DRAINAGE REPORT
FOR
Hunters Ridge Subdivision

April 1992

D. MARK GOODWIN & ASSOCIATES, P.A.
CONSULTING ENGINEERS & SURVEYORS

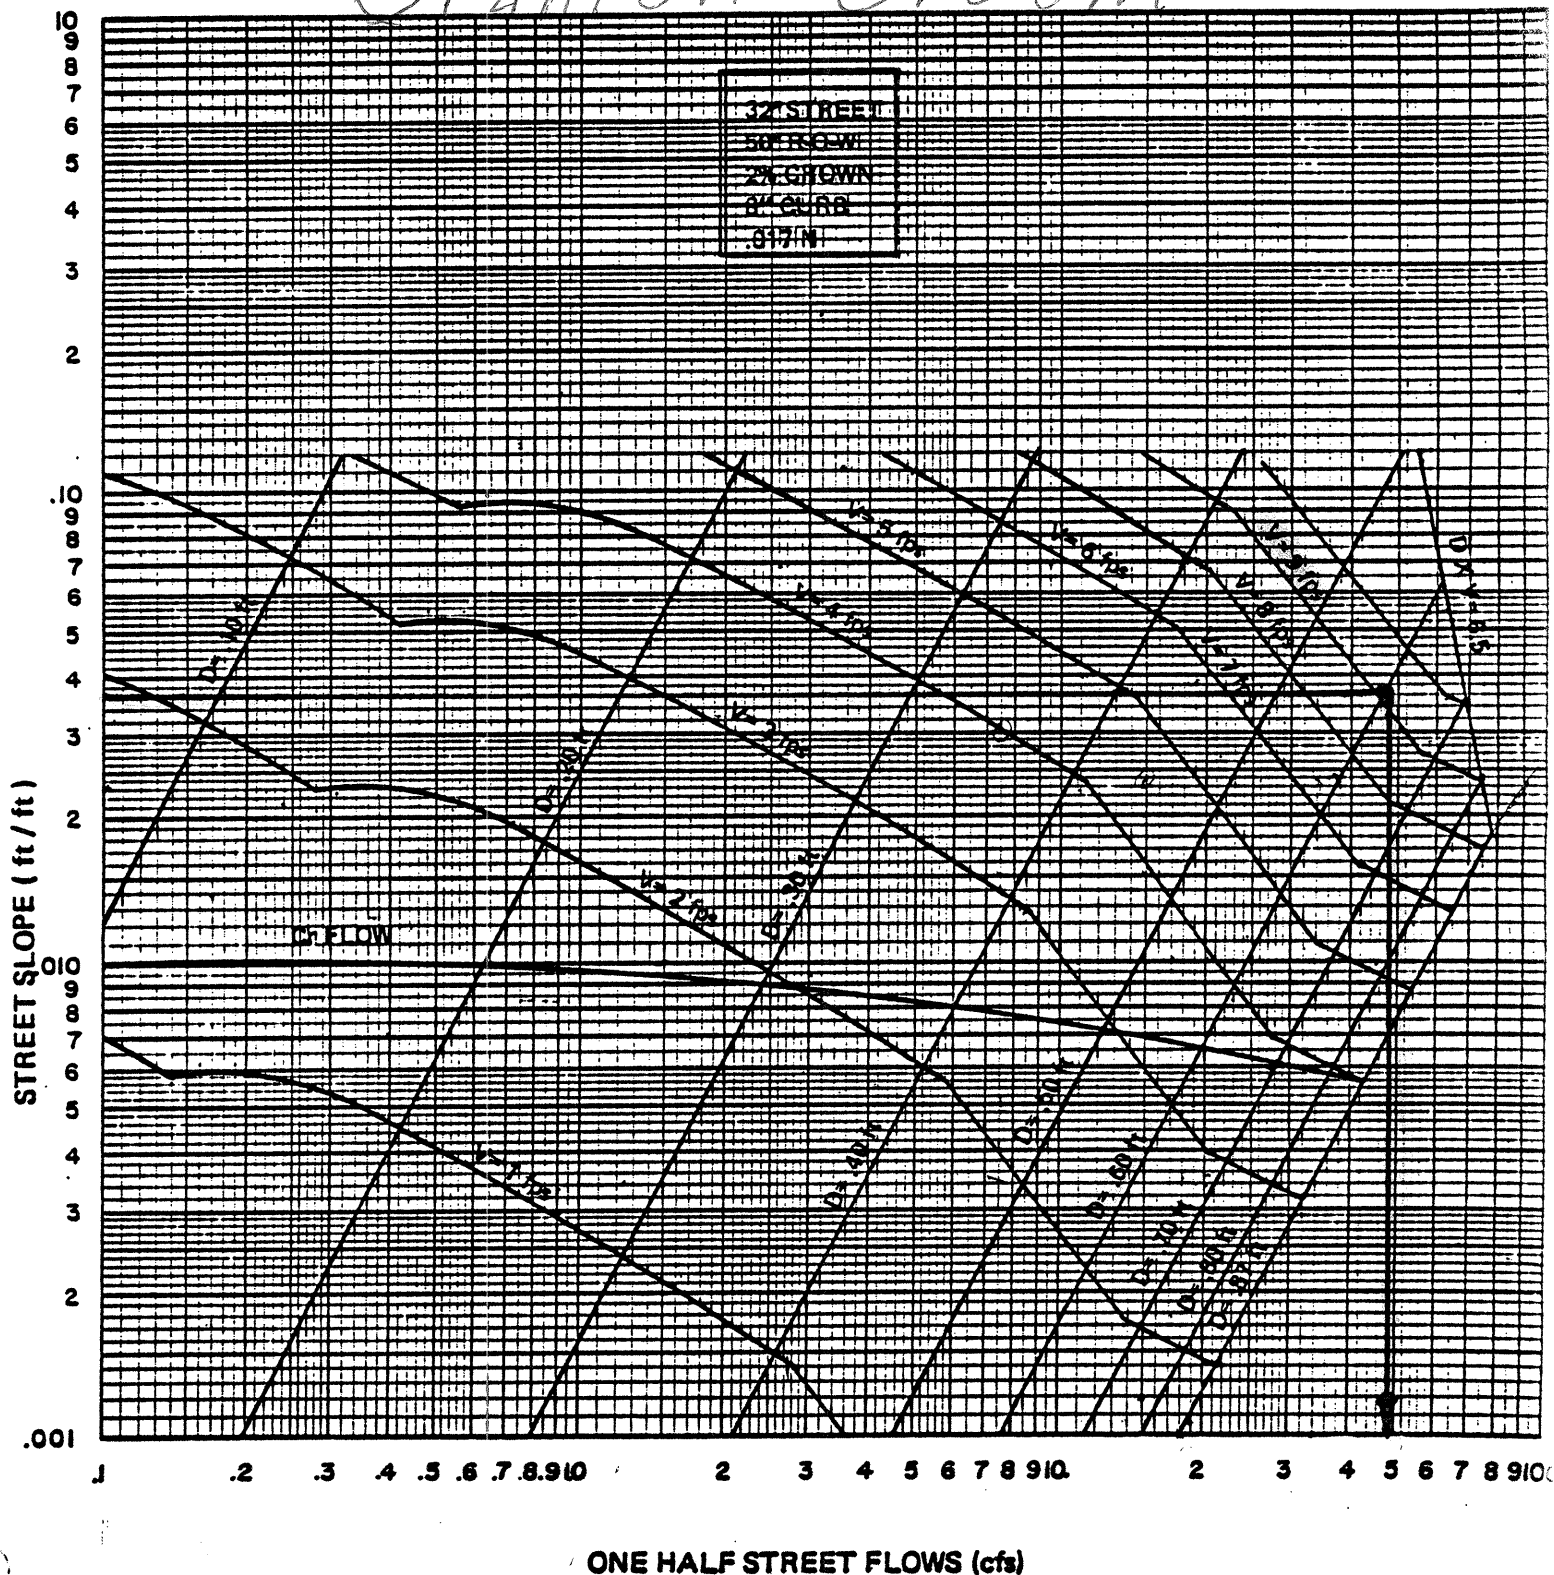
Per attached nomograph ^{SHT 6?} Capacity of
Spanish Broom = 76 cfs > 56 cfs
98?
